EPC STORMWATER REVIEW COMMENTS  
IN ORANGE BOXES WITH BLACK TEXT

## FINAL DRAINAGE REPORT

### MAYBERRY, COLORADO SPRINGS – FILING NO. 4

SF2317

**MAP NUMBER**  
08041C0809G

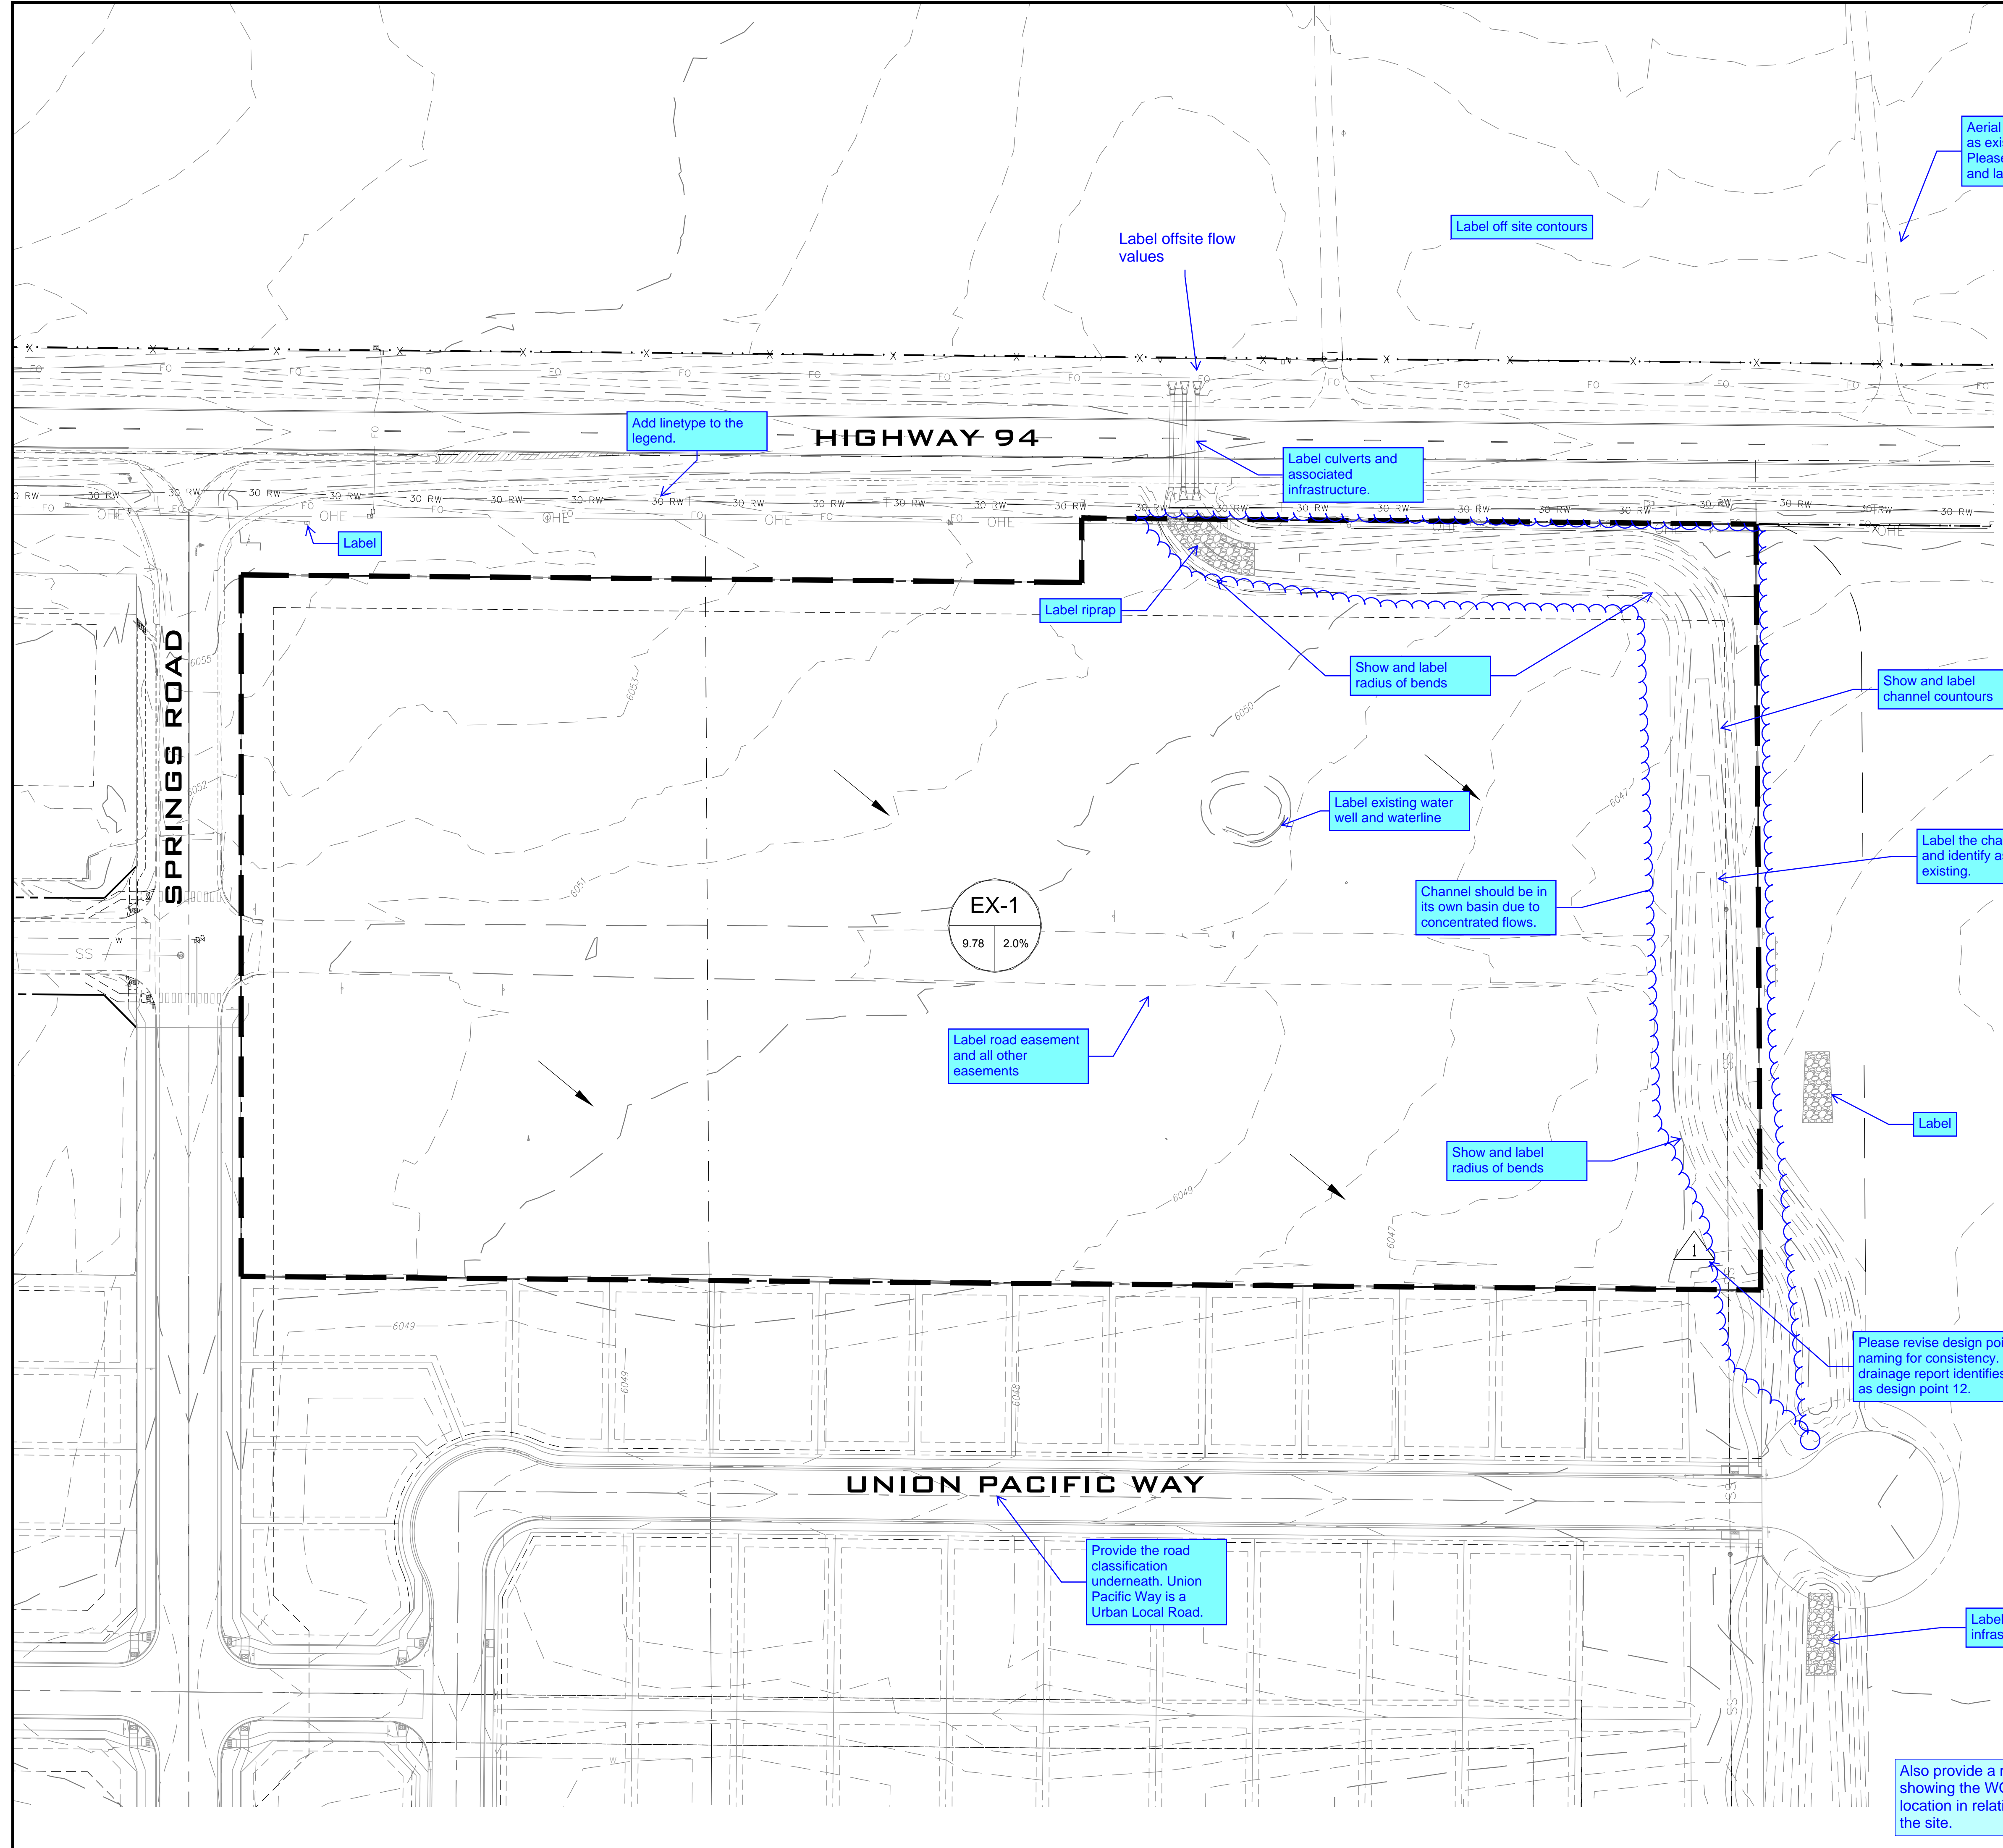
provide 810G also

Basin	Area (acres)	5-yr (cfs)	100-yr (cfs)
EX-1	9.78	1.98	13.29

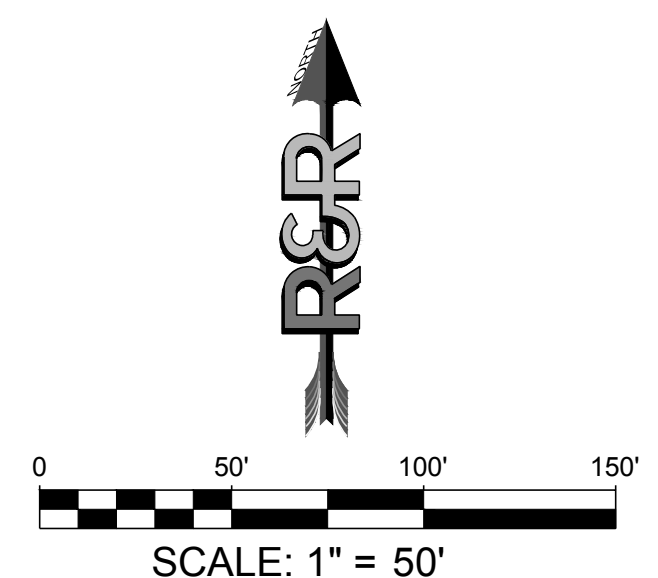
Show and label the time of concentration path. Add to the table and legend.

Show and label all existing infrastructure and structures.

Also provide a map showing the WQ pond location in relation to the site.

Add "PCD File No. SF2317"

DRAINAGE BASIN LABEL	PROPOSED
* BASIN LABEL	C-1*
** TRIBUTARY AREA (AC)	1** 2**
*** IMPERVIOUS (%)

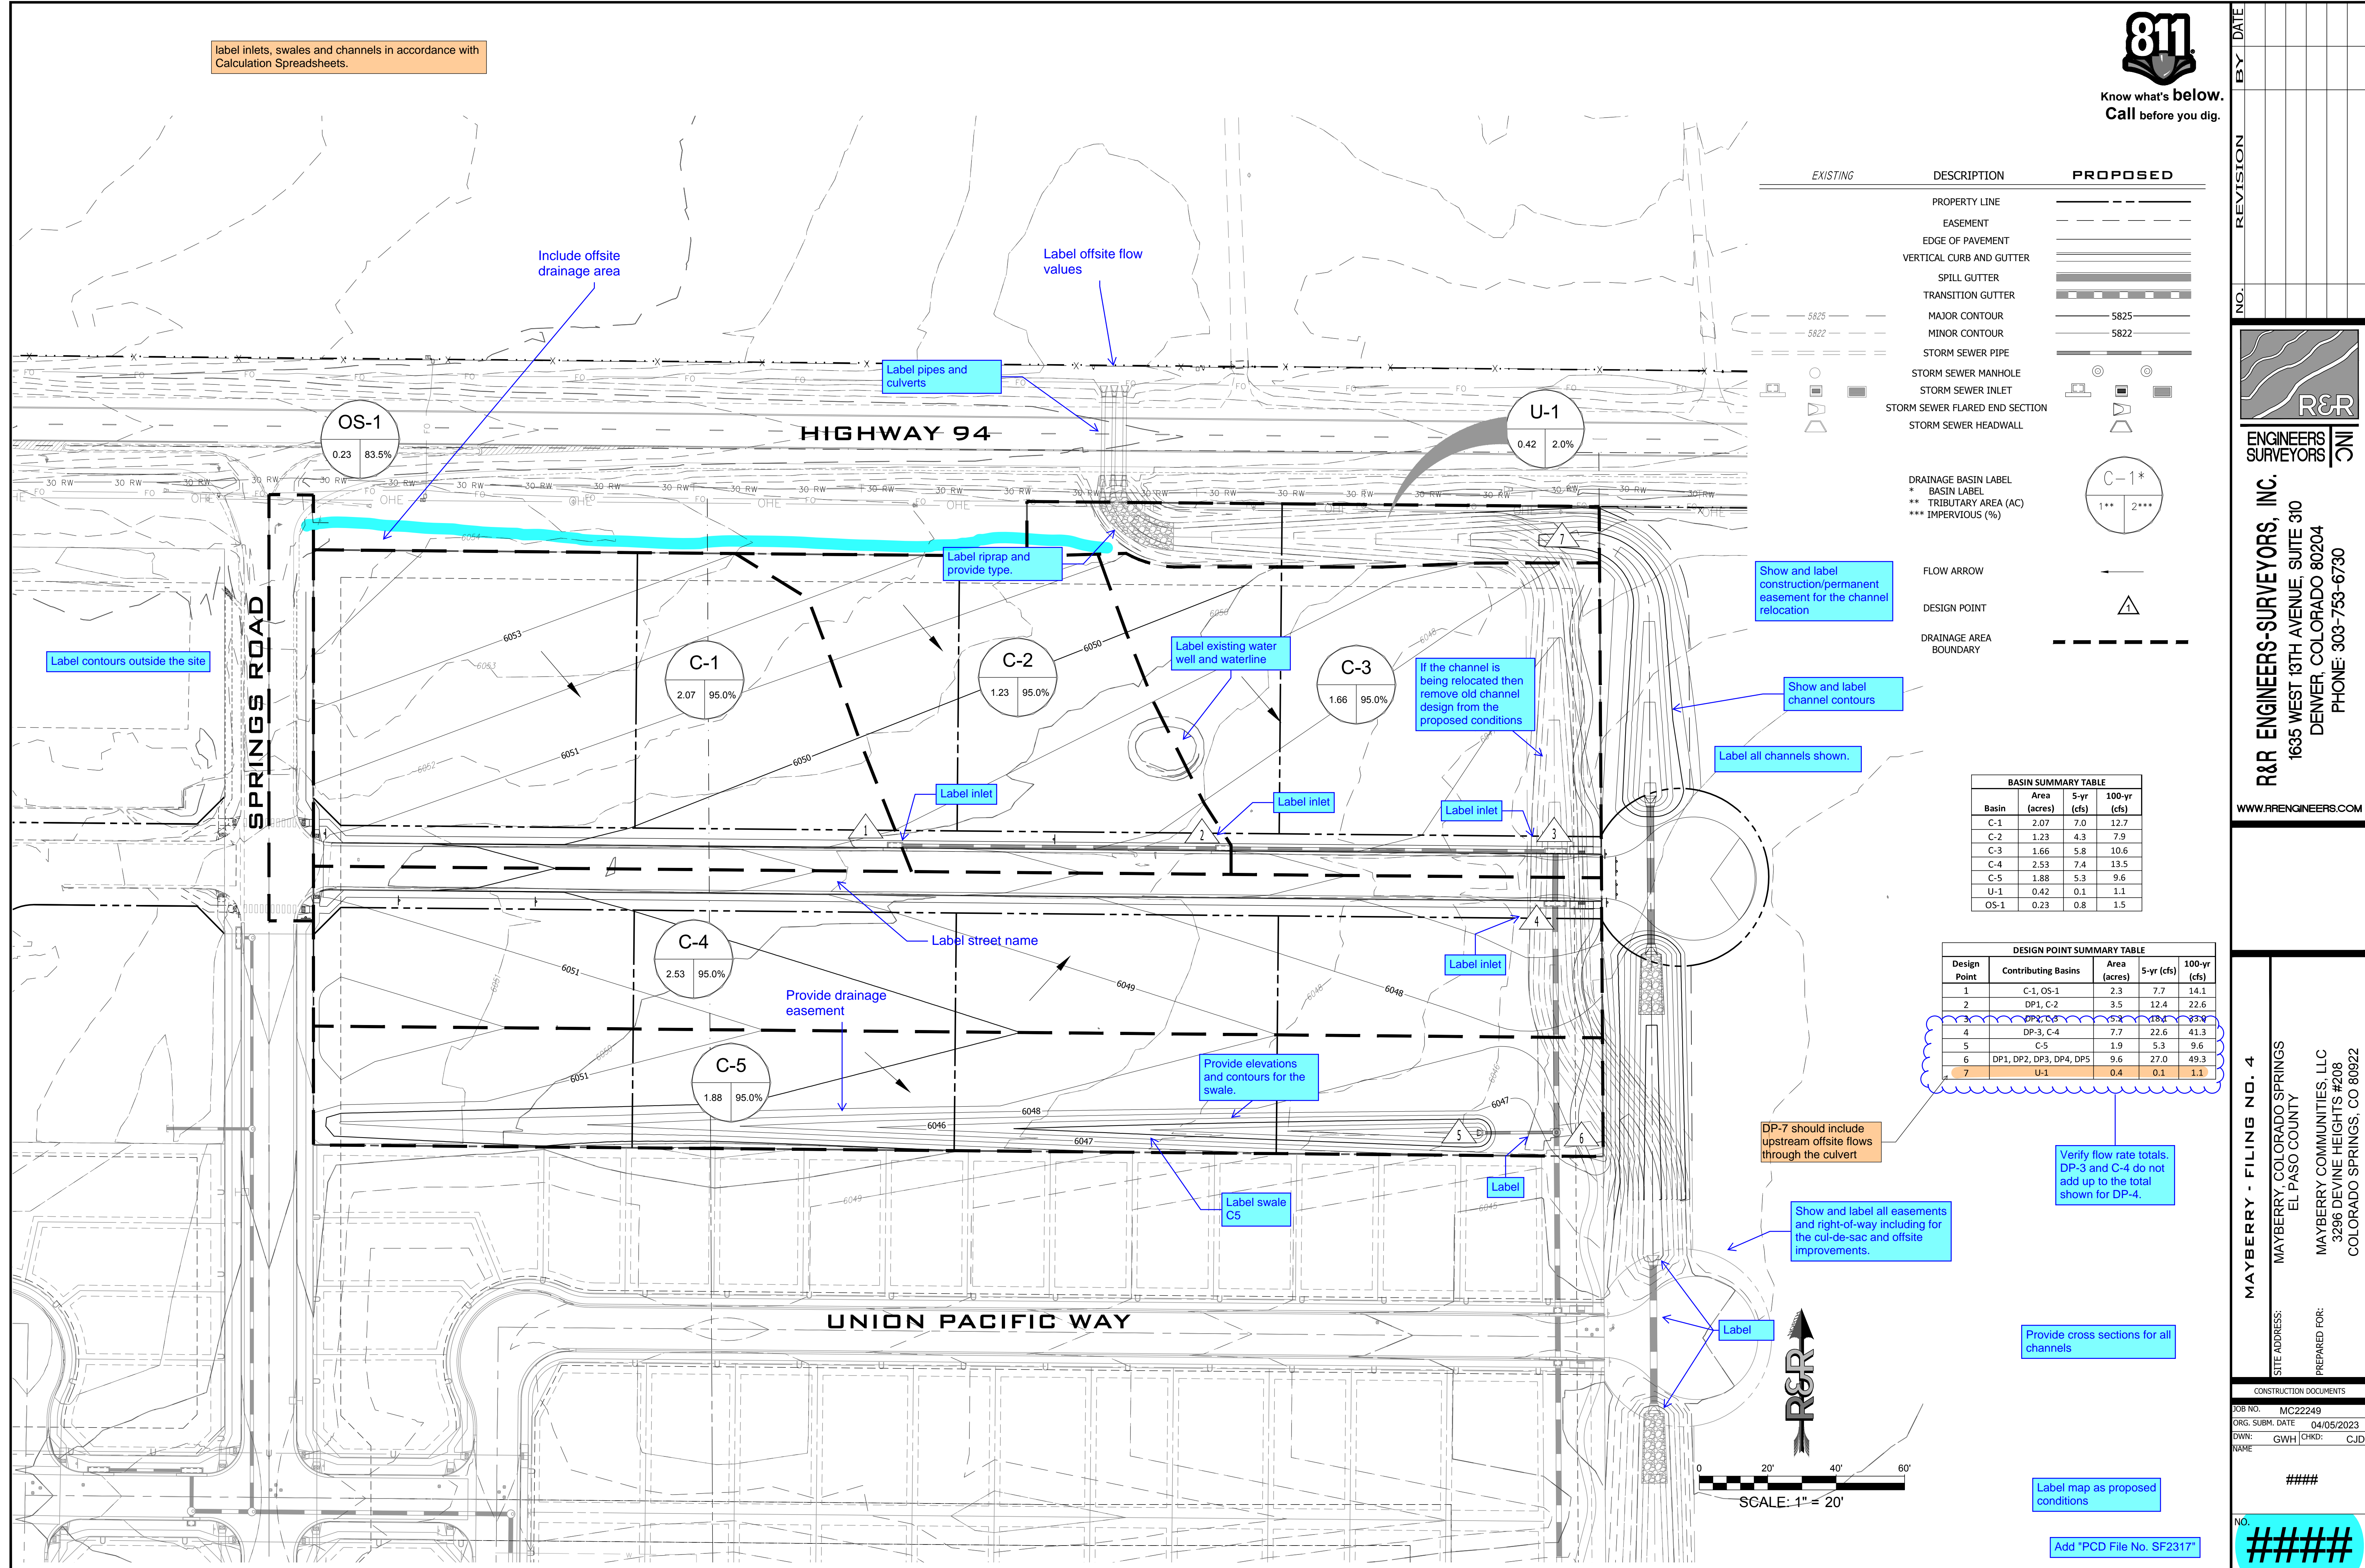
label inlets, swales and channels in accordance with Calculation Spreadsheets.

Add PCD File No. SF2317
